# SERVICE BULLETIN

## M1450: Milwaukee-Eight Equipped Vehicles - Loss of Power or High Engine Braking

**M1450** 2017-11-15  
 Milwaukee-Eight: 107ciMilwaukee-Eight: 114ciMilwaukee-Eight: 117ci

Figure 1. Cam Support Plate Tightening Sequence

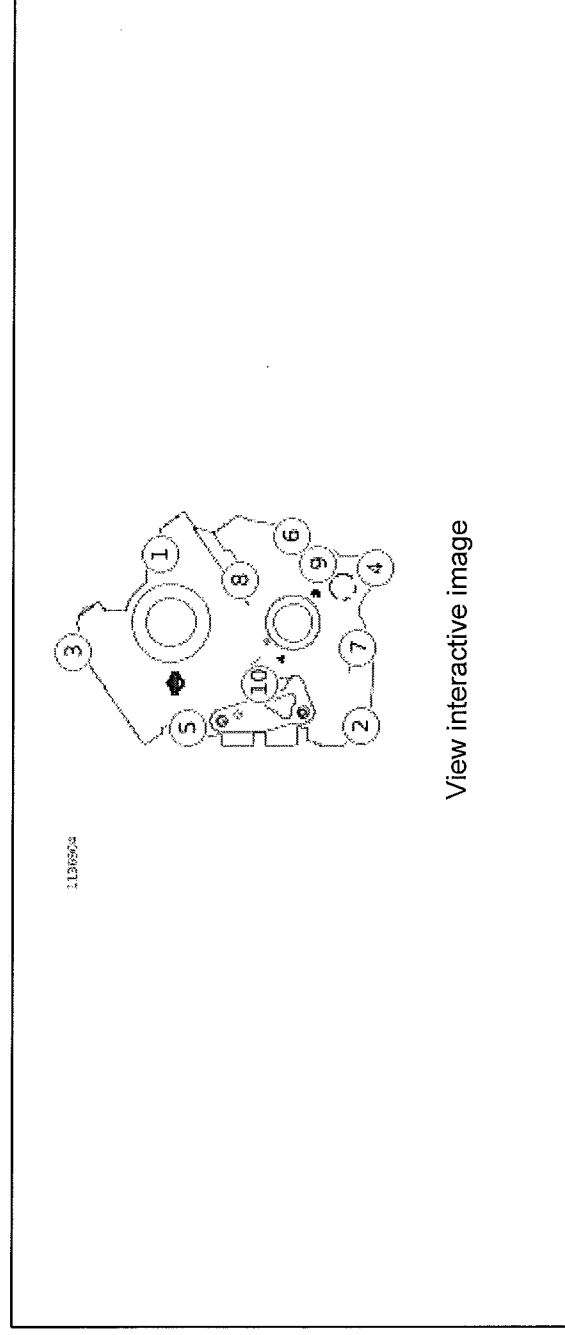
1. Install cam support plate. See the service manual.
2. **Refer to Figure 1.** Follow modified tightening sequence.

- a. Tighten screws 1–6.
- b. Rotate crankshaft 360°.
- c. Tighten screws 7–10.

Torque: 10.4–12.7 N·m (92–112 in-lbs)
